Modification **B**ulletin

Model: Kir-C Fax Օր	e: 31-May-0	1	No.: MB404001			
Modified Article: P	arts Catalog Correction		Prepared	by: K.	Miura	
From: Technical Ser		•				
Reason for	□ Parts catalog correction	☐ Vendoi	r cha	ange	☐ To n	neet standards
Modification: ☐ To facilitate assembly		☐ To improve reliability		()	
	☐ Part standardization	☐ Other

Model: Kir-C Fax Օր	otion	Da	ate	: 28-Aug-0	1	No.: MB404002	
Modified Article: Right Flat Cable Plate			Prepared by: K. Miura				
From: Technical Ser	vices Dept., GTS Division						
Reason for	☐ Parts catalog correction	☐ Vendor	cha	ange	☐ To m	neet standards	
Modification:		☐ To improve reliability		()		
	☐ Part standardization	☐ Other

Page 3

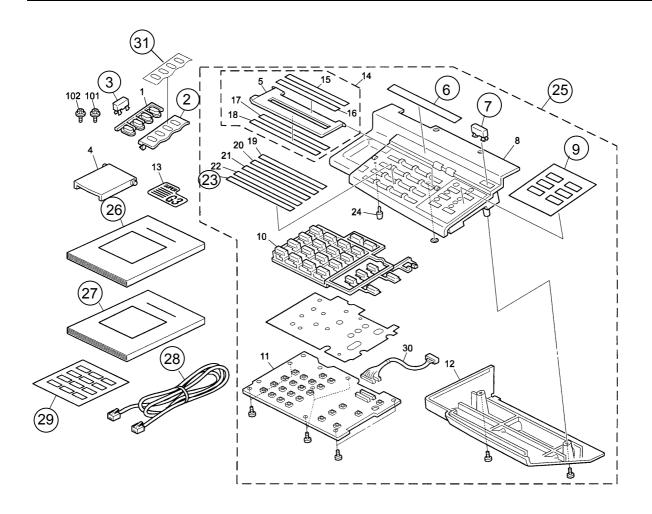
Part number	Old description	New description	Q'ty	Index	Note
B4041482	Switch Cover (EU)	Switch Cover (EU/CHN/TWN)	1	2	
B4041483	Copy Key (EU)	Copy Key (EU/CHN/TWN)	1	3	
B4041455	Sheet Fax	Sheet Fax (NA/Asia)	1	6	
B4041480	Fax Key (EU)	Fax Key (EU/CHN/TWN)	1	7	
B4041456	Sheet Function	Sheet Function (NA/Asia)	1	9	
B4041467	Decal Dial Lower	Decal Dial Lower (NA/Asia)	1	23	
B4041422	Operation Panel (EU)	Operation Panel (EU/CHN/TWN)	1	25	
H5235350	Telephone Cable	Telephone Cable (NA)	1	28	
B4041476	User Function Key Decal	User Function Key Decal (NA)	1	29

Page 5
- Description Changes -

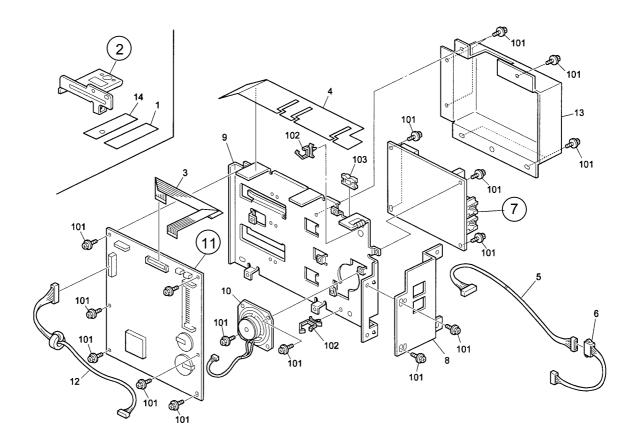
Part number	Old description	New description	Q'ty	Index	Note
B4045821	Handset Bracket	Handset Bracket (NA)	1	2	
B4045184	NCU Board (EU)	NCU Board (Except for NA)	1	7	
B4045166	FCU Board (Asia)	FCU Board (Asia/CHN/TWN)	1	11

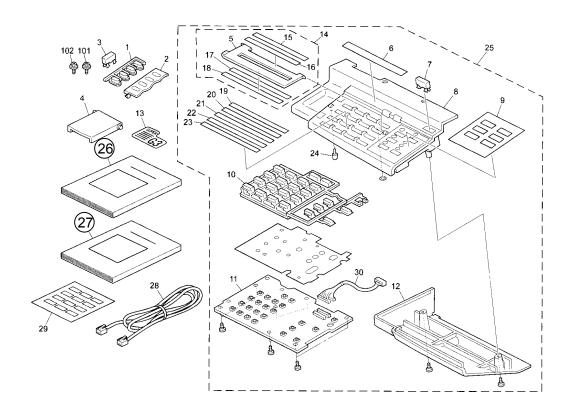
To include the duplex machine information into the Operating Instructions, the following parts have been changed:

Old part	New part	Description	Q'ty	Int	Page	Index	Note
number	number						
B4048607	B4048611	Operation Manual (NA)	1	X/O	3	26	
B4048657		Operating Instructions - Advanced (NA)	1	X/O	3	27
